**Correspondence Between  
Staff and Applicant  
Approval Letter**

**Item No.** 5  
**Topic:** 2-DR-2019 (Cabana on Hayden)  
**Action Requested:** Stipulation Modification  
**Meeting Date:** July 18, 2019  
**From:** Jeff Barnes, Senior Planner JB  
**Through:** Steve Venker, Development Review Board Coordinator

The Planning & Development Services Division has completed the review of the above referenced development application submitted on 3/4/2019. The following **2<sup>nd</sup> Review Comments** represent the review performed by our team, and is intended to provide you with guidance for compliance with city codes, policies, and guidelines related to this application.

Y2K Engineering, LLC. (Y2K) has been retained to prepare a traffic impact statement for the proposed Cabana on Hayden development located on the southwest side of Hayden Road and Oak Street in Scottsdale, Arizona. The proposed multi-family residential development will consist of approximately 89 units. Two driveways are proposed: one full access on Oak Street and one right-in and right-out only access on Hayden Road. The existing zoning of the site is R-5. Figure 1 depicts the site location.

Figure 6: Site Volumes for First Scenario

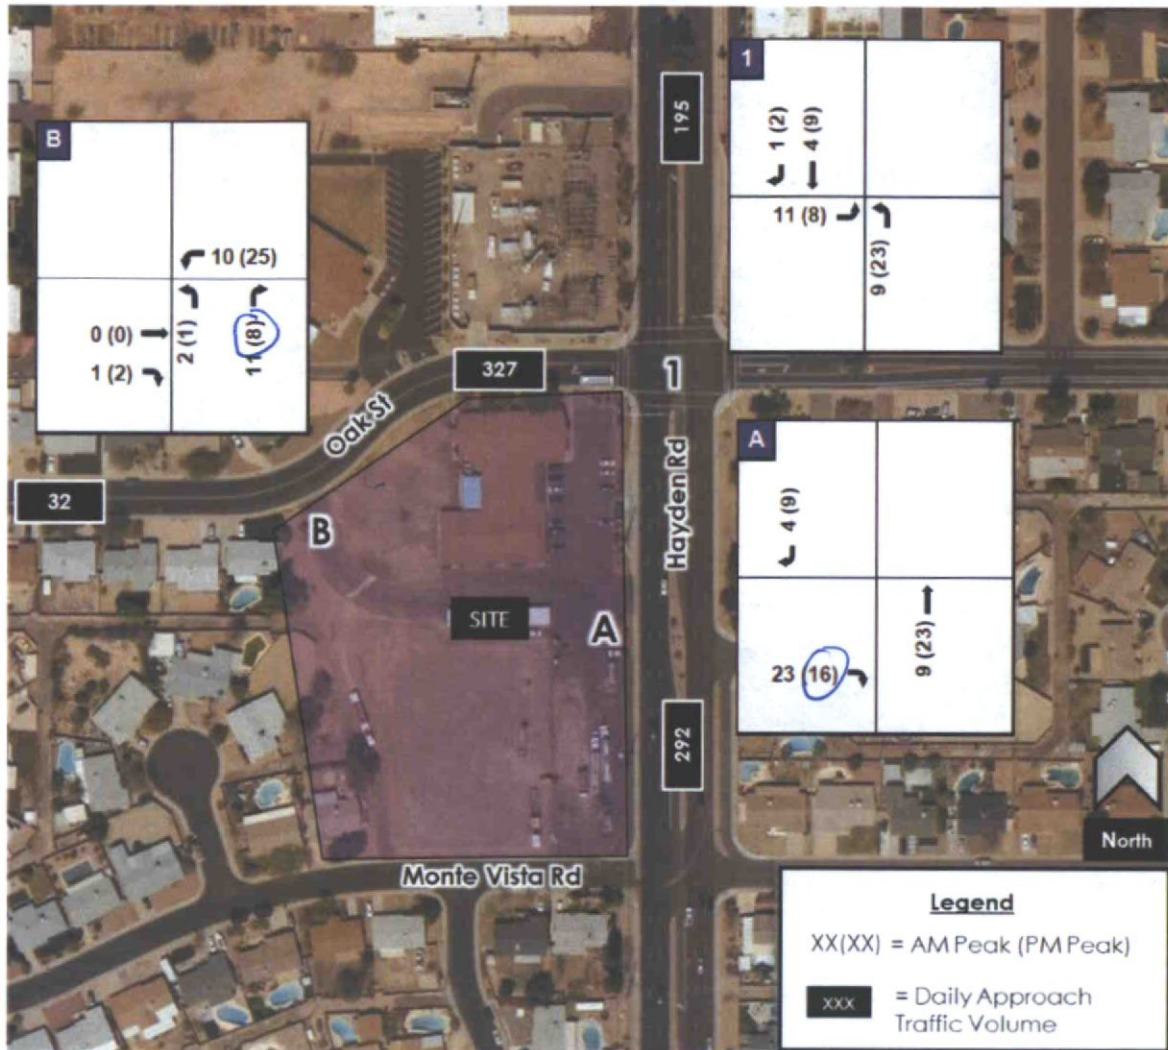
3	COS		Page 6, Figure 5	D. Ostler	Should the red "65%" be "100%"? Should a black "65%" be shown making a U-turn at the intersection of Hayden Road & Oak Street? Verify arrows with percentages shown at the limits of the study area.	A	A	K. Fletcher	Corrected to be more clear.
4	COS		Page 7, Figure 7	D. Ostler	– The site traffic volumes do not appear to be consistent with Table 1 and Figure 5. Verify eastbound, northbound through and southbound right turn volumes at Driveway A. Verify northbound U-turn and southbound through volumes at Hayden Road and Oak Street.	A	A	K. Fletcher	Corrected to reflect driveway volume.
5	COS		Page 8, 1st Paragraph	D. Ostler	For future studies, please clarify when the stated criteria applies. See <i>Design Standards and Policies Manual</i> Section 5-3.206.	A	A	K. Fletcher	Will do. Language added to TIS
